RE: Veolia Repairs and Improvements North and South of Broadway

# **Attachment A**

## AMGEN STEAM SERVICE RELOCATION.

<b>COM/STEAM</b>		
CAMBRIDGE		
STEAM(6") & CONDENSATE(4") SERVICE TO		
AMGEN, ONE KENDALL SQ.-BUILDING 600		
R.J. Pinea	DRAWING NO. N7827	REV.

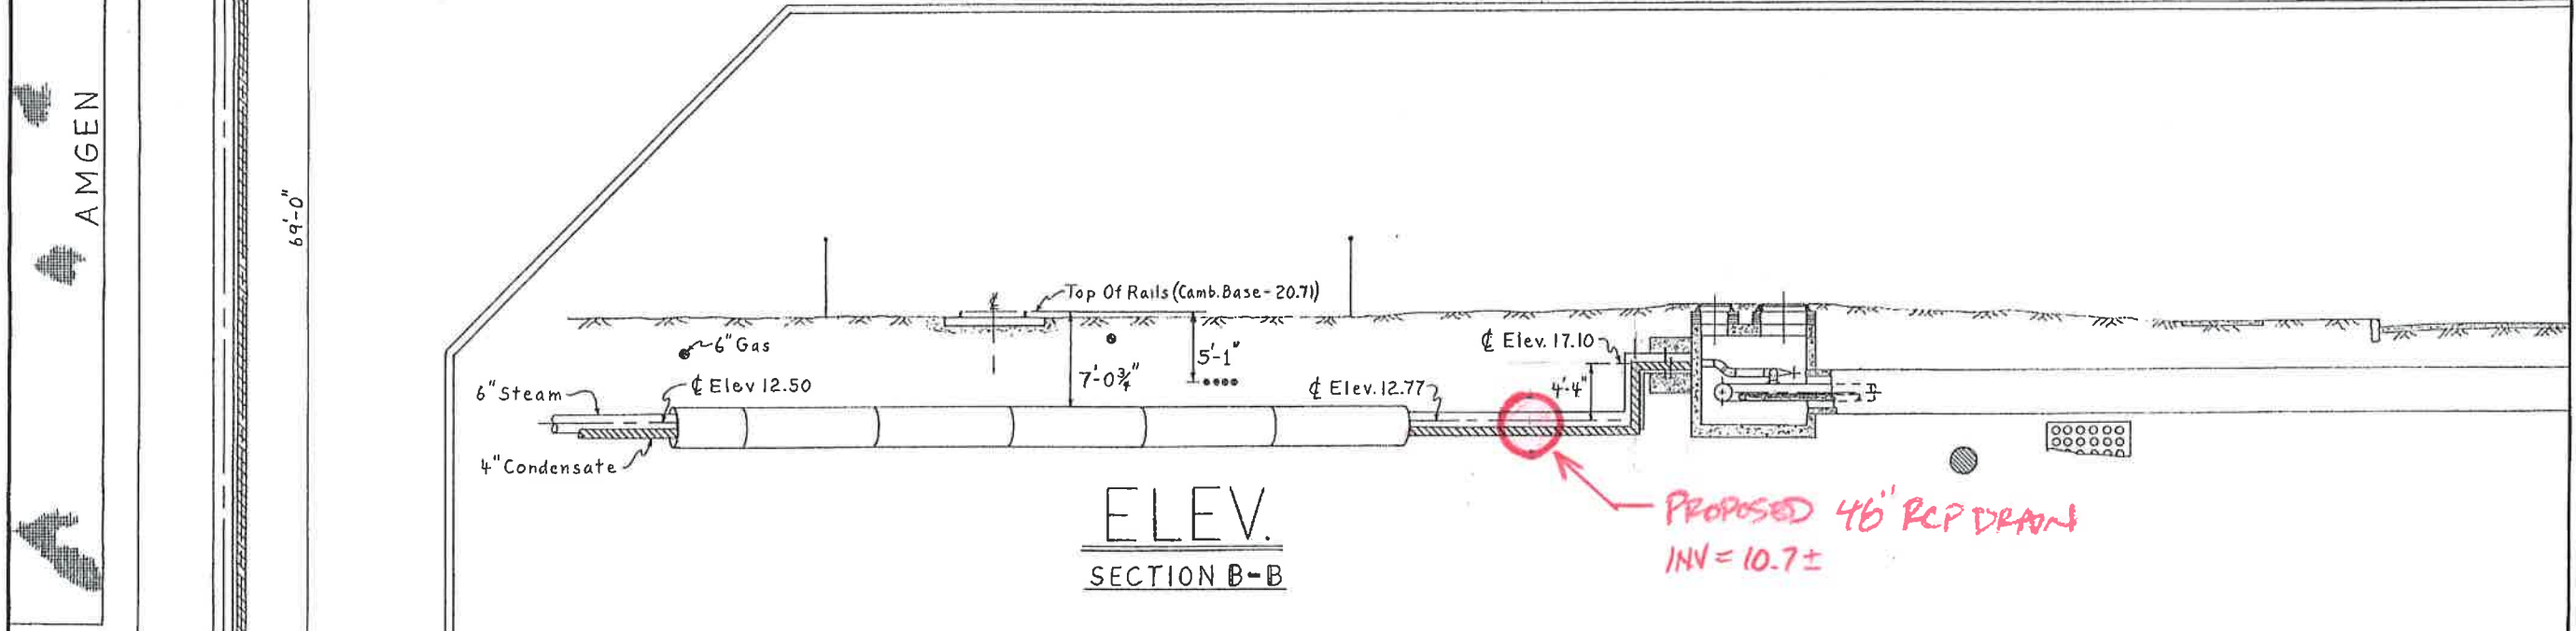
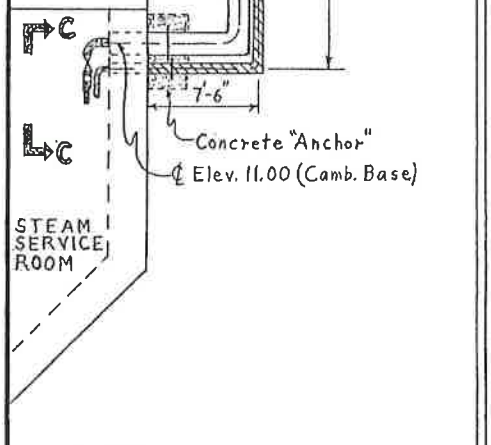
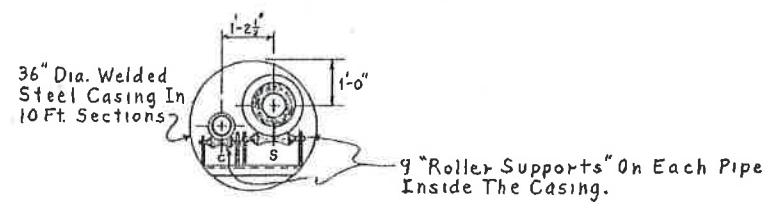
Currently Amgen steam service is provided by a buried 6" steam line, and associated 4" condensate line, extending from the western side of Veolia Steam structure K-18 and running west across the CSX/MBTA railroad right-of-way. This steam service is depicted in both plan and profile on a plan title "COM/STEAM AMGEN, ONE KENDALL SQ.-BUILDING 600, dated 11/13/00". The steam service exits structure K-18 at an approximate elevation of 17.10 and drops to an elevation of 12.77 approximately 5' outside of structure K-18 to cross beneath the railroad tracks through an existing 36" steel casing pipe. At its current elevation of 12.77, the existing steam service would create a conflict with the proposed City of Cambridge DPW Project 9ab 48" RCP gravity drainage pipe. We request that the steam service be relocated to allow for the installation of the proposed 48" RCP drain. The existing and proposed steam pipe relocation is graphically depicted on the two attached sketches labeled Attachment B.

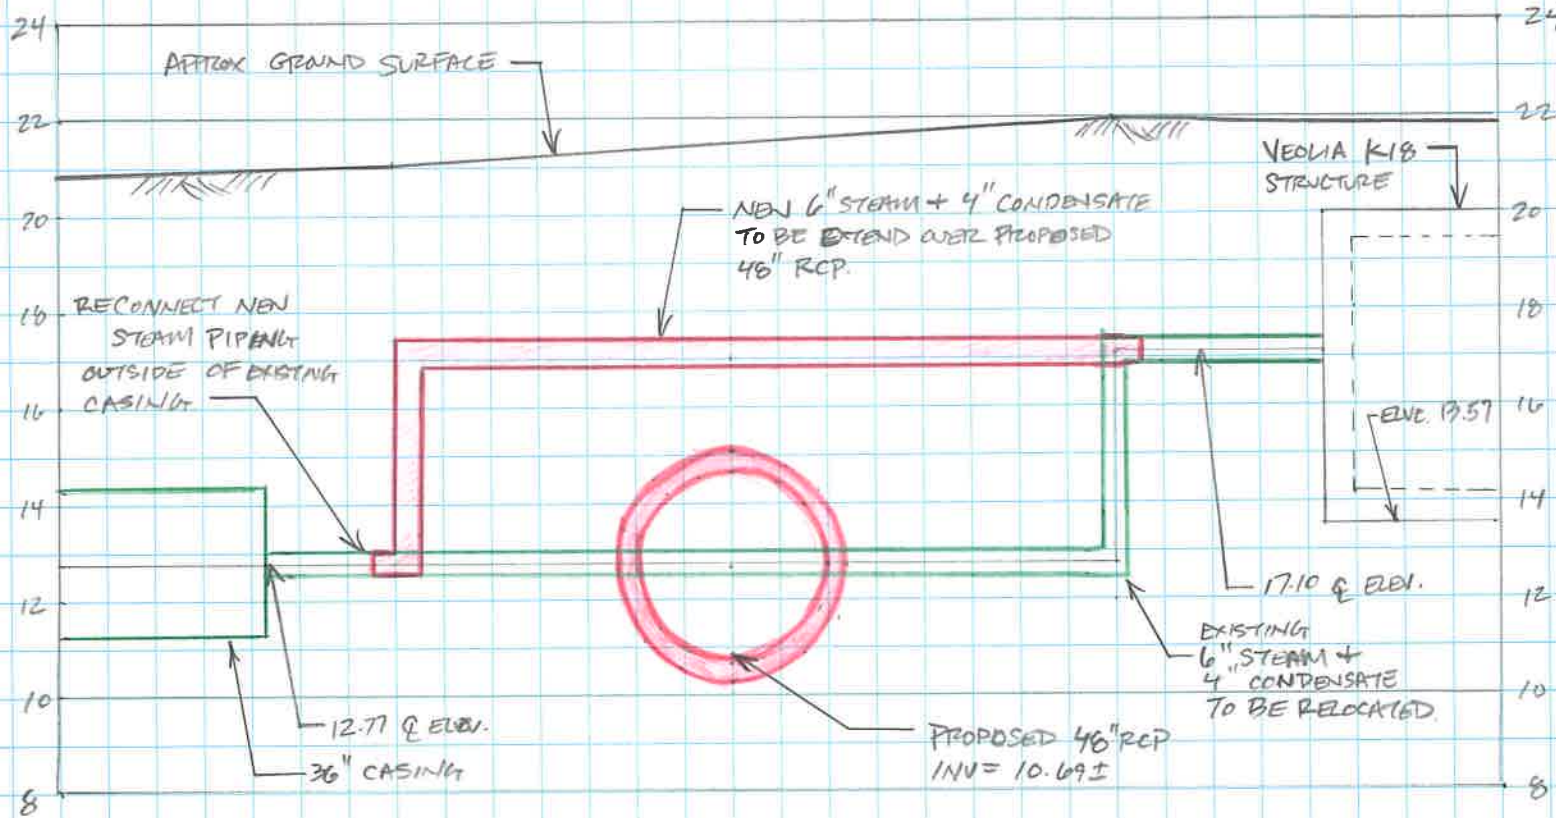
- NOTES: 1. REMOVE AND RELOCATE EXISTING 6" STEAM AND 4" CONDENSATE.
2. STEAM SUPPLY SHALL NOT BE INTERRUPTED TO AMGEN. CONTRACTOR TO COORDINATE TEMPORARY SERVICE AS REQUIRED.
